EPC STORMWATER REVIEW COMMENTS
IN ORANGE BOXES WITH BLACK TEXT

GRANDWOOD RANCH

ROAD AND STORM PLANS

| FOR AND ON BEHALF OF MATRIX DESIGN GROUP, INC. PROJECT No. 20.1120.003 | DESIGNED BY: CAP DRAWN BY: CAP CHECKED BY: NMS SCALE: HORIZ N/A VERT. N/A DATE ISSUED: SEPTEMBER 2020 SHEET 4 OF 38 DRAWING No. TY01 |

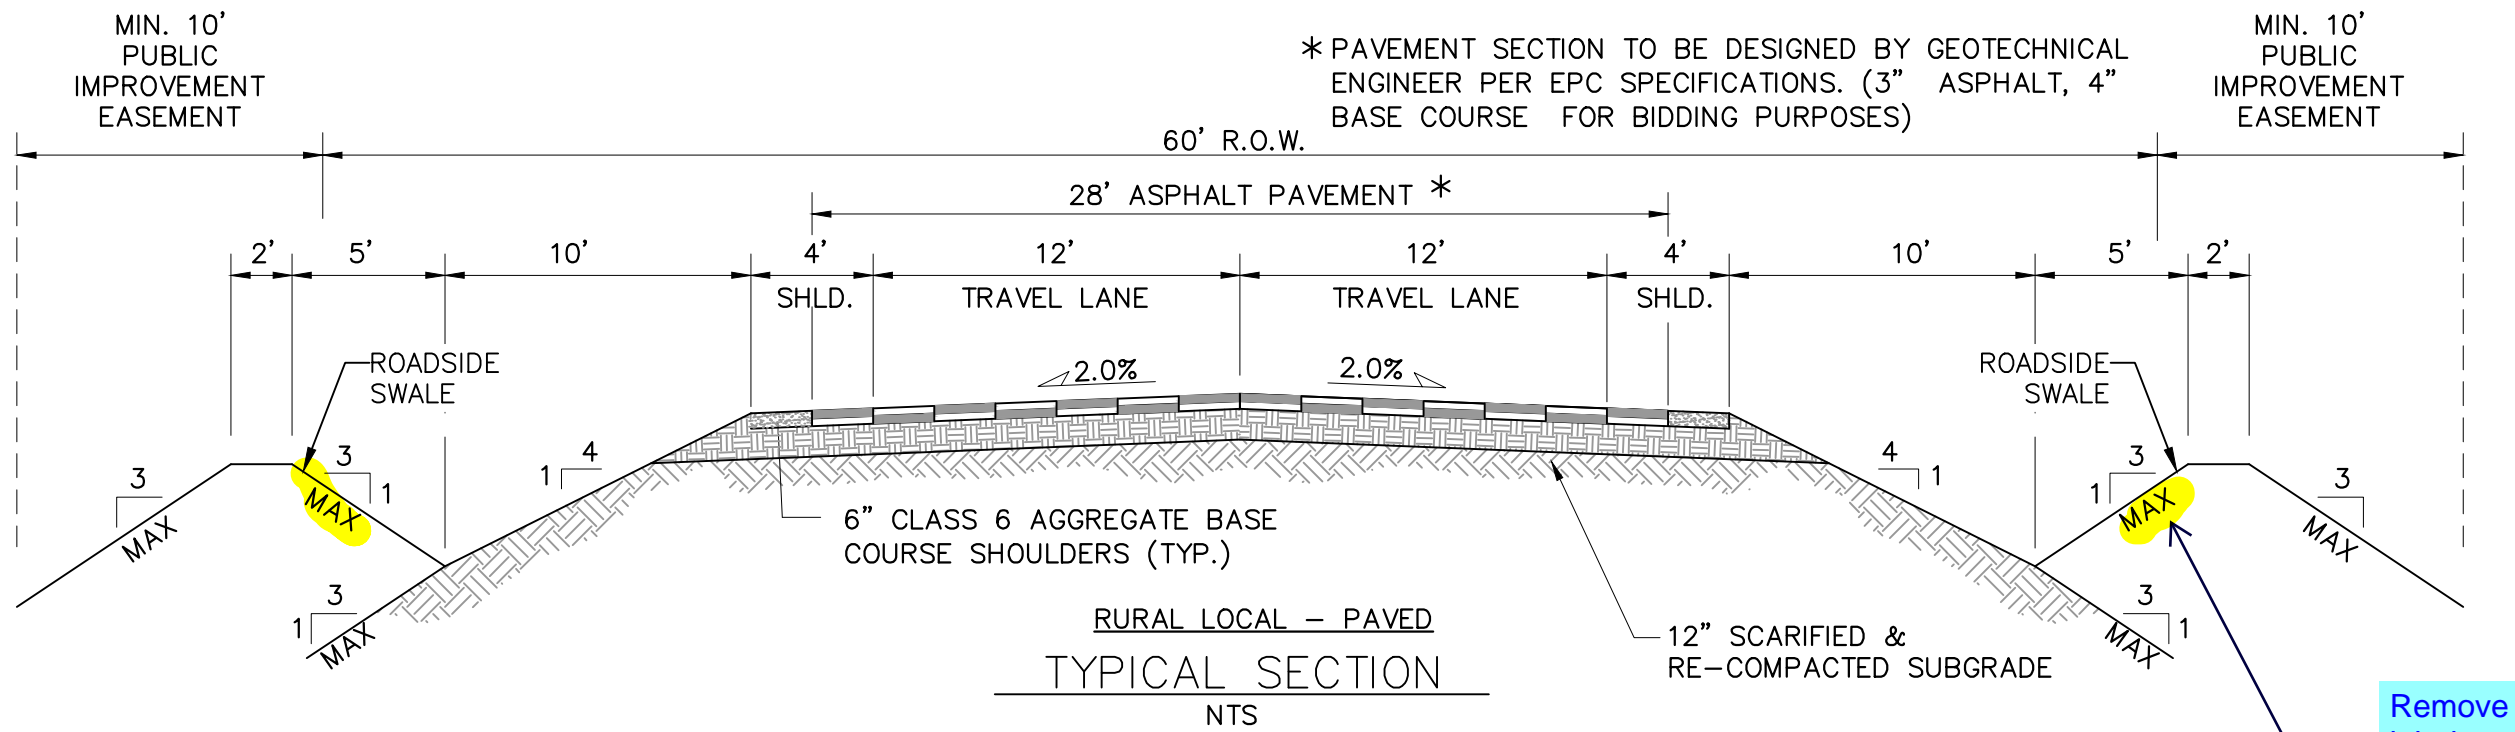
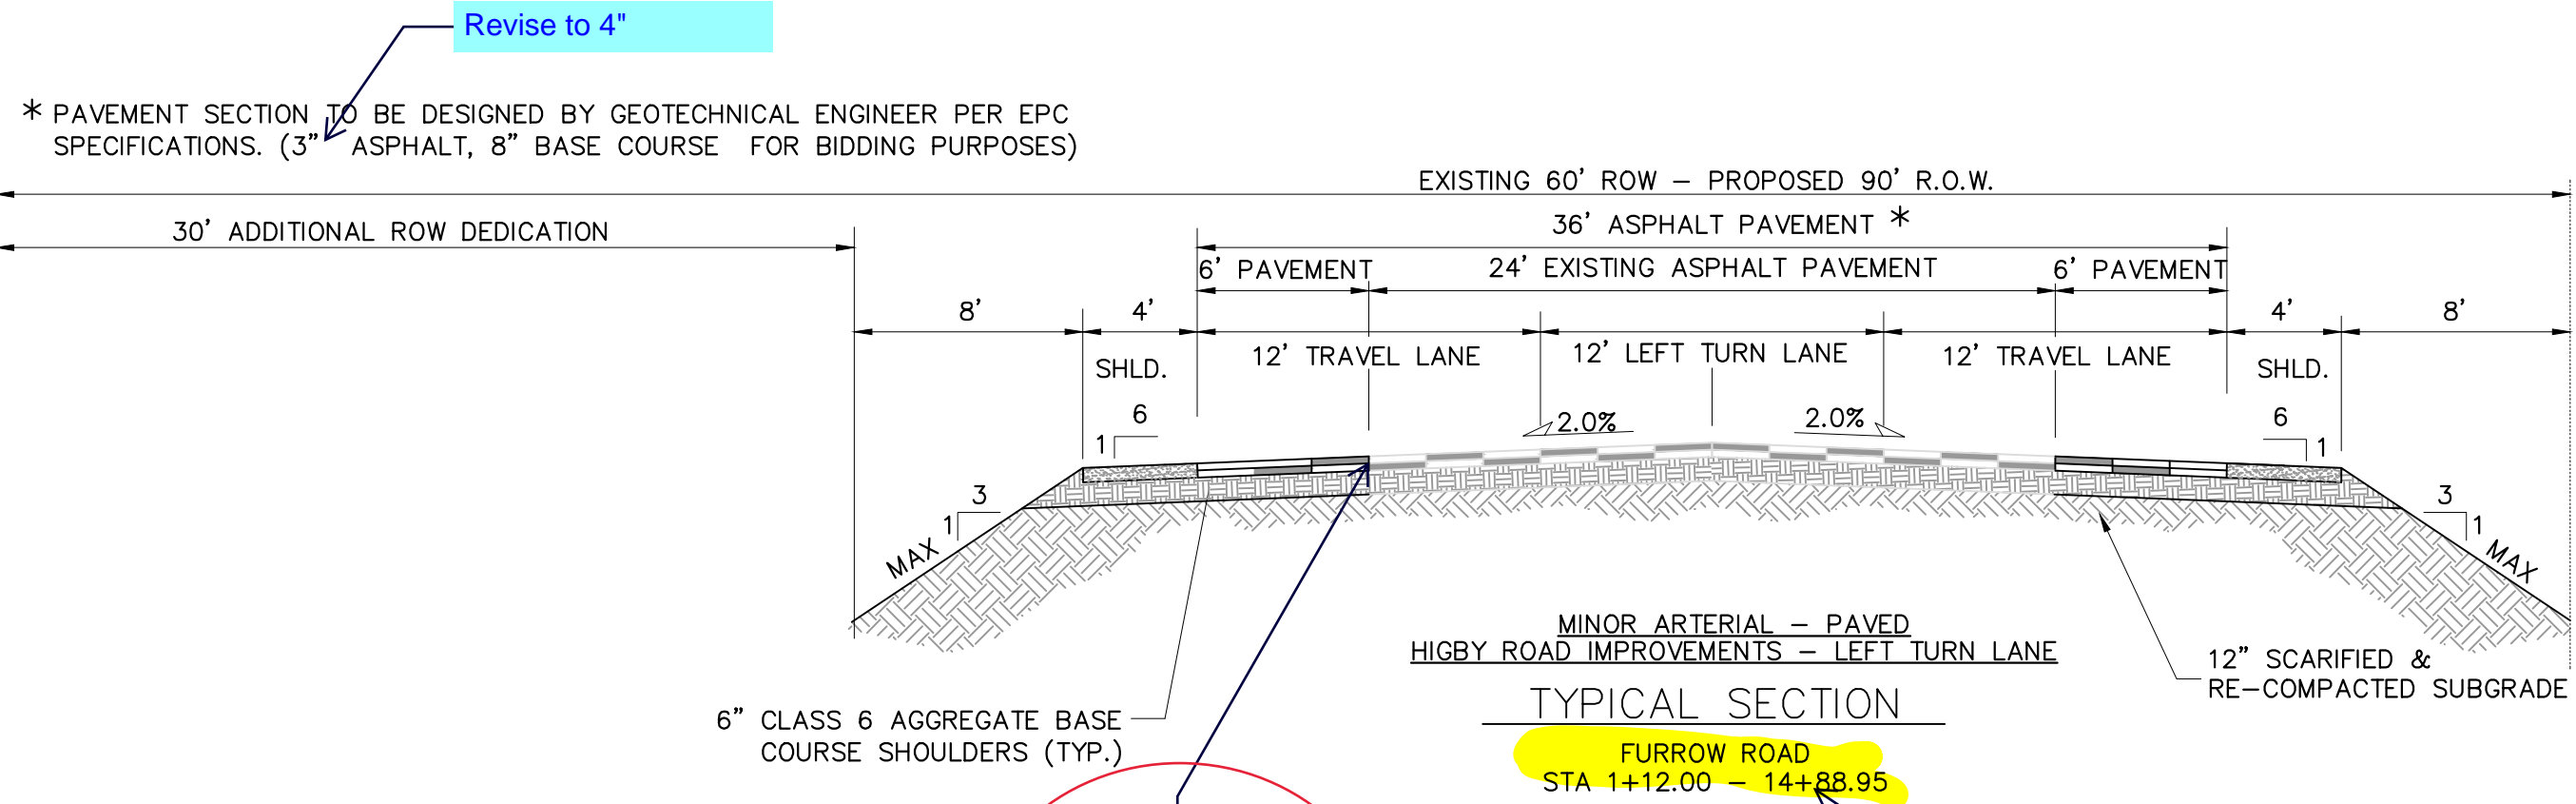
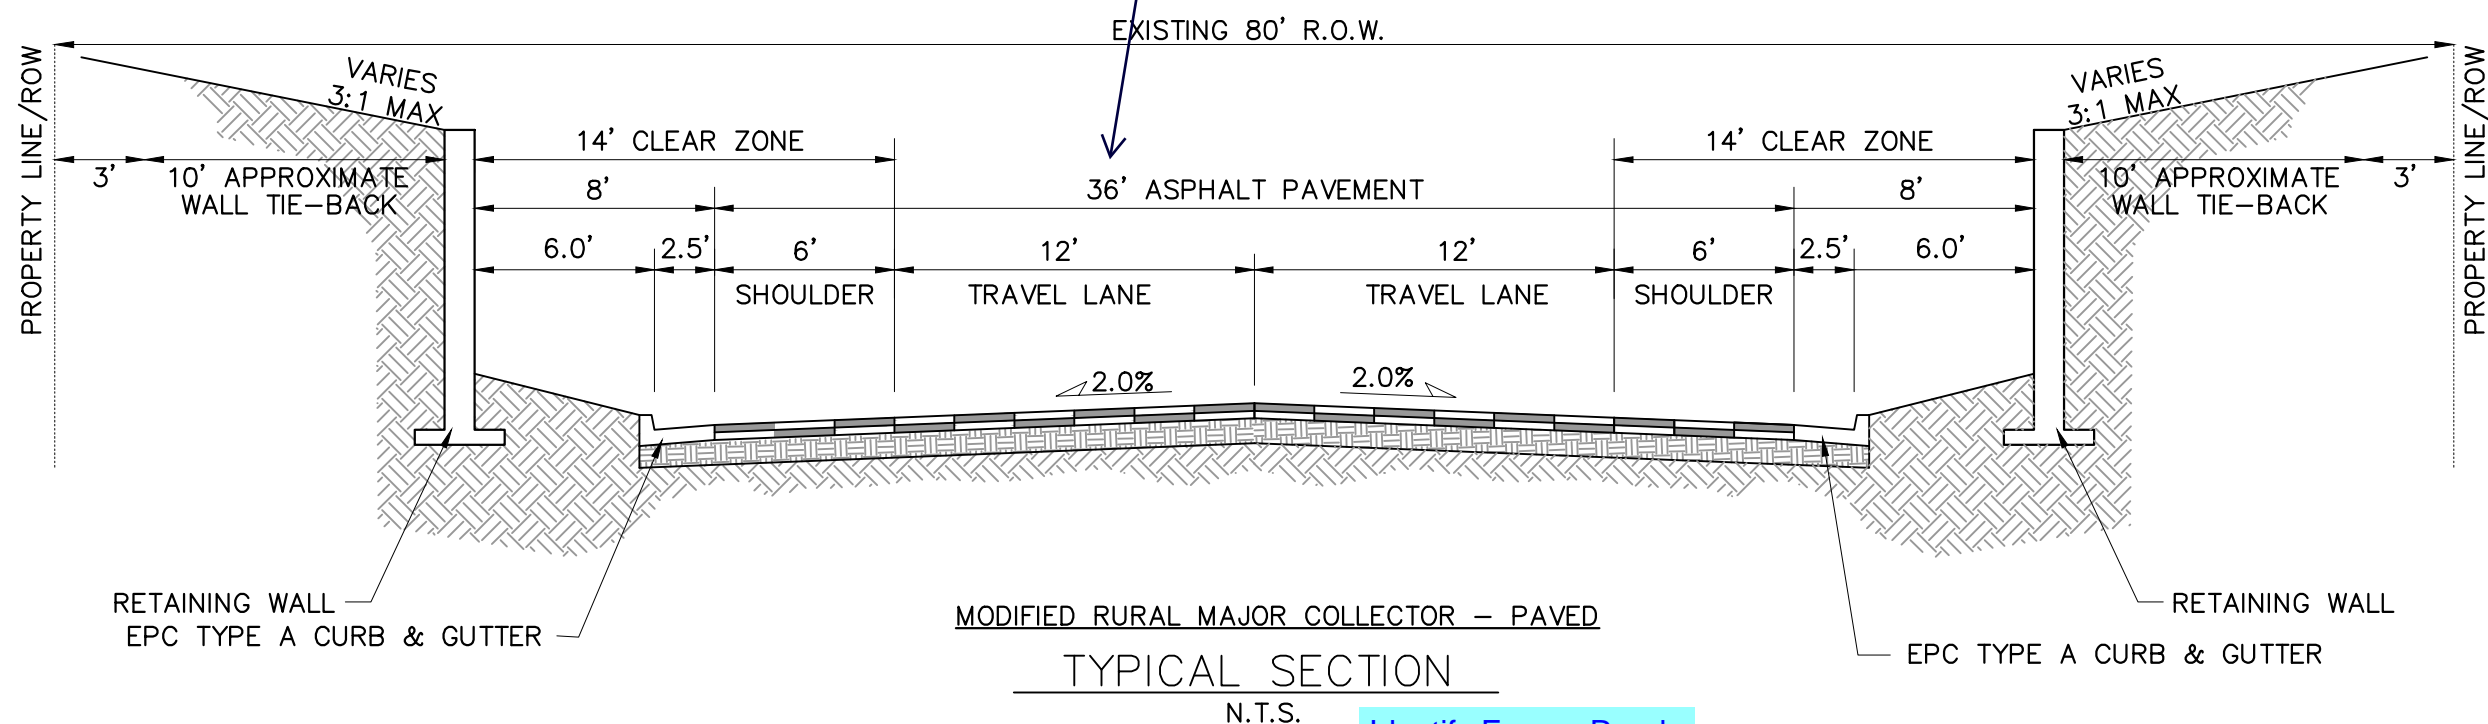
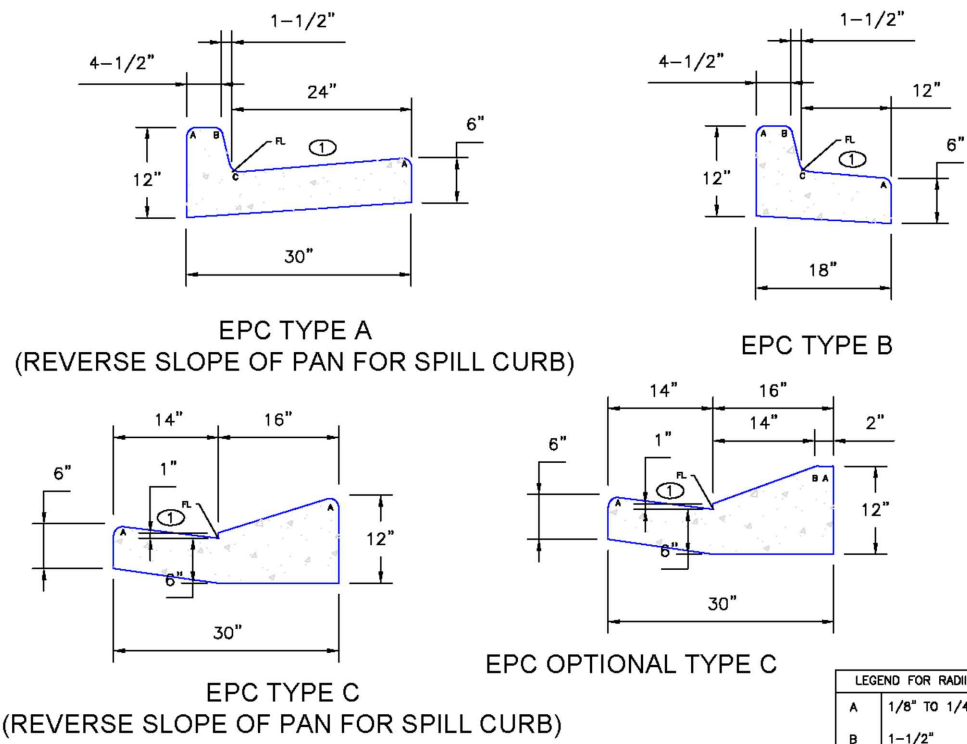
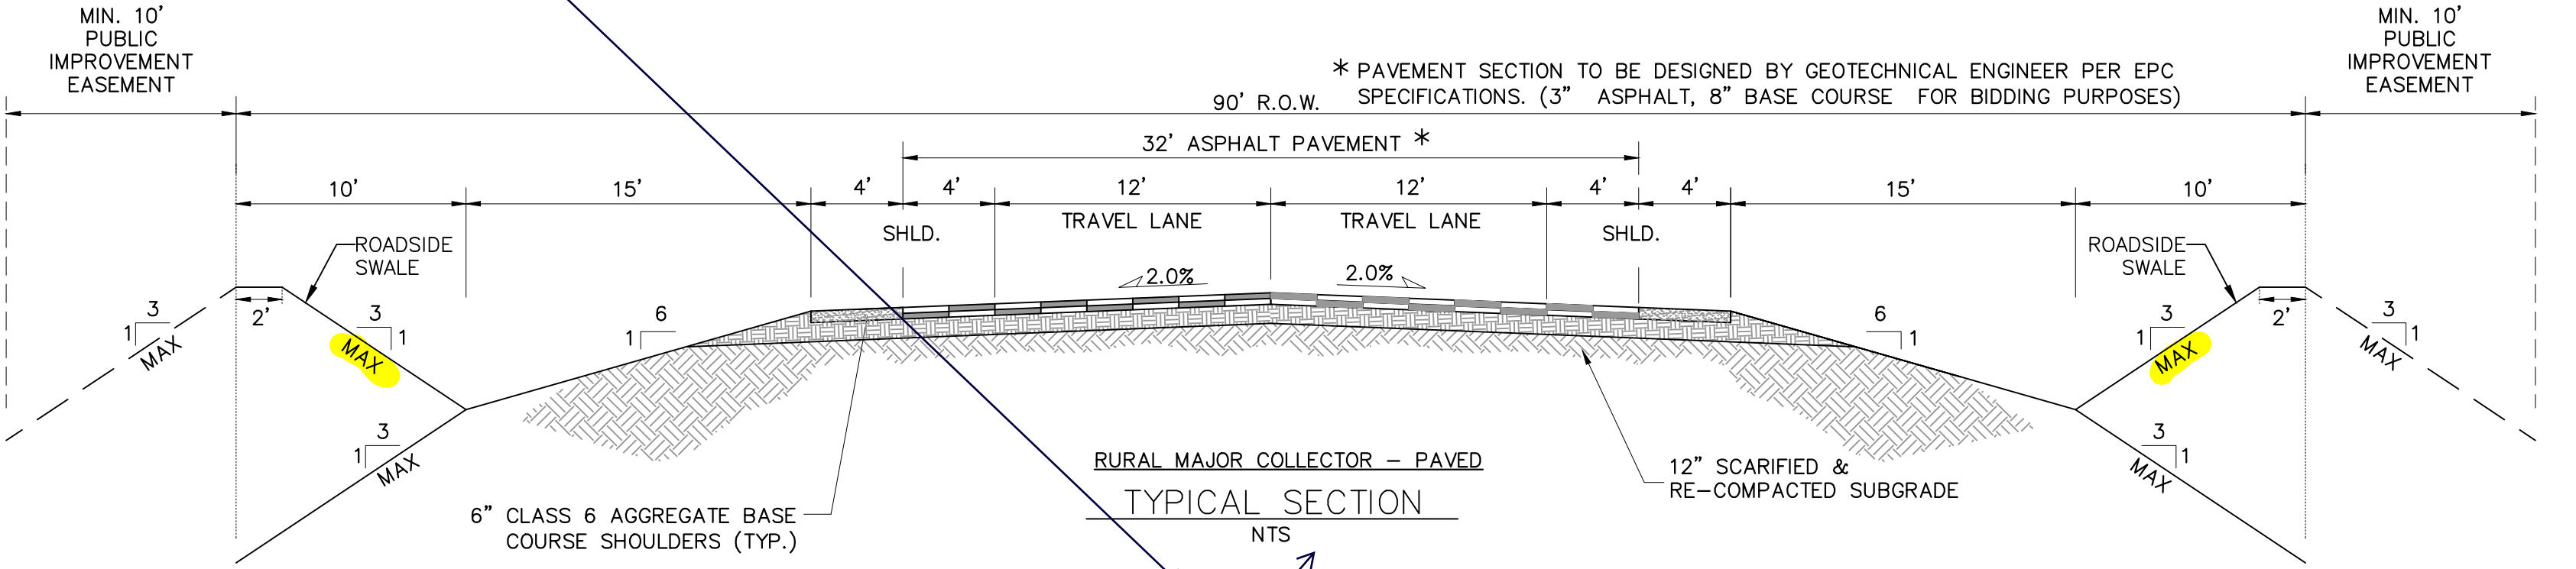
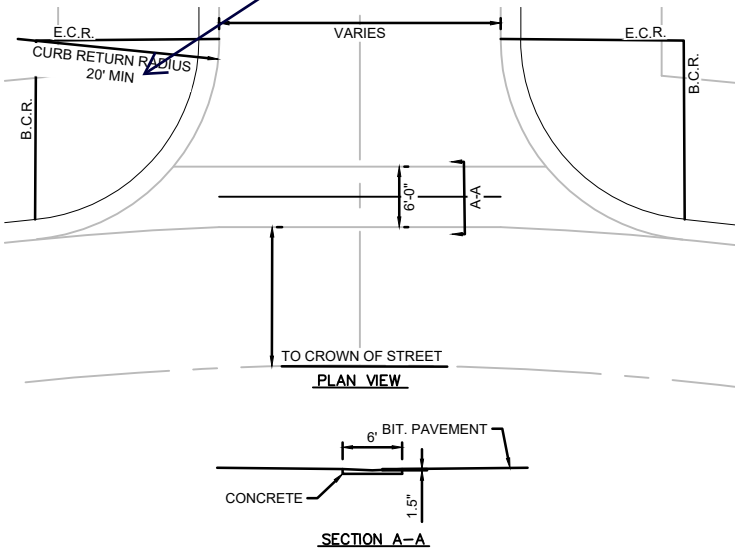
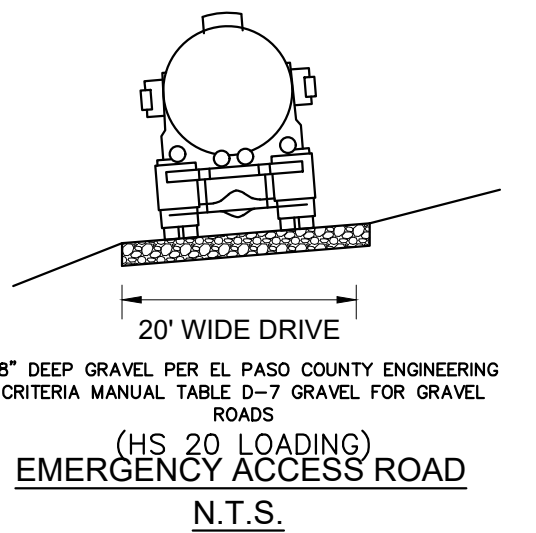
Final design is pending coordination between EPC DPW and the applicant.

Identify 4" Asphalt over 8" ABC

Provide construction detail for the "T-patch" mill/overlay. See the Trails at Aspen Ridge Fil 1 construction plans sheet RM01-B

Move label to the Rural Major Cross section detail

Remove the "max" label on the backslope (highlighted) or identify the minimum required roadside ditch depth.

Identify Furrow Road (Sta x - Sta y)

Clarify. If this is C&G, 20' min radius is measured from flowline

Reference the approved deviation request from the design standards for Rural Major Collector per the preliminary application (SP195) and list the approved design modification.

Under each road section list the street names the given cross section applies to.

Notes regarding deviation requests have been added to Sheet GN02

| ROADWAY KEY MAP | | | |

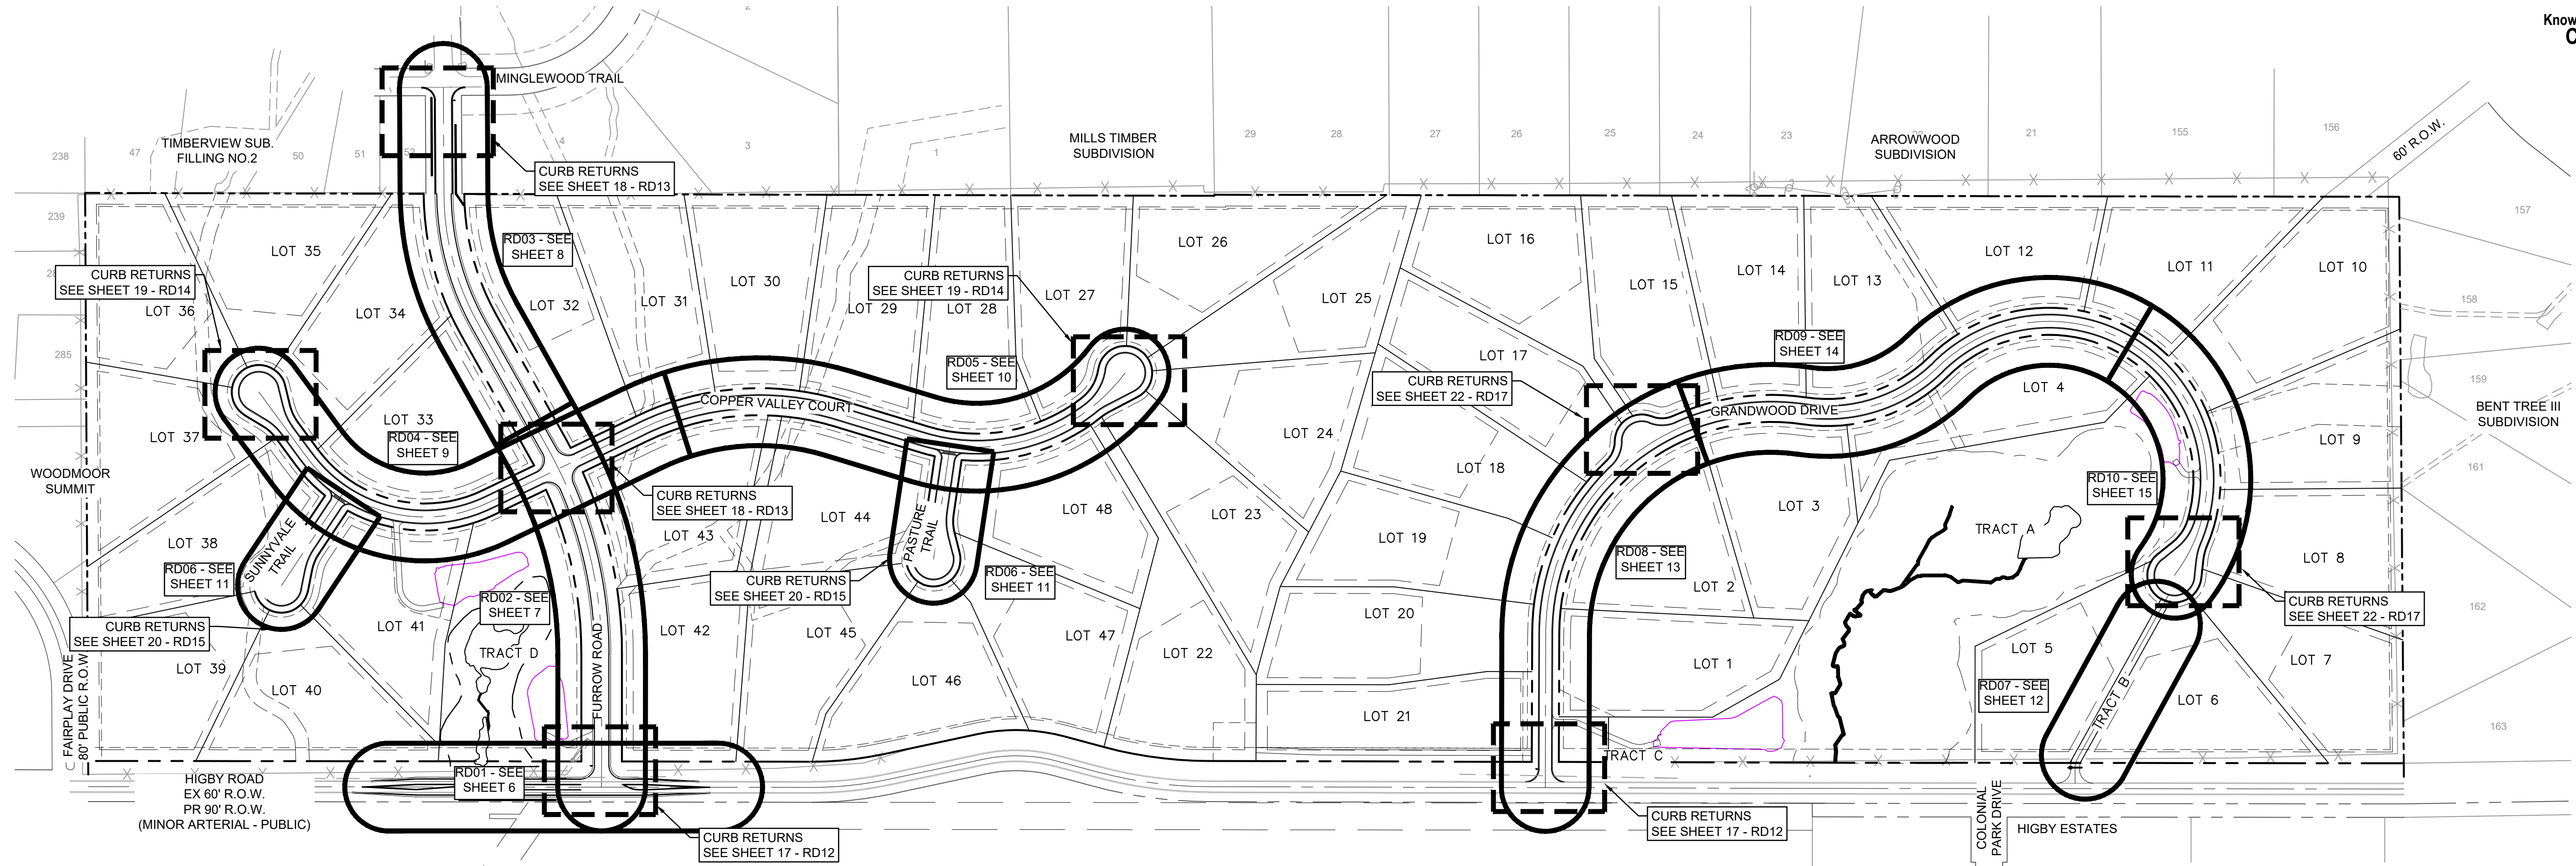
Add scale block and north arrow.

Please provide street classifications, design speed.

Refer to ECM for all of these requirements.

A note has been added to this specifying classification and design/posted speed
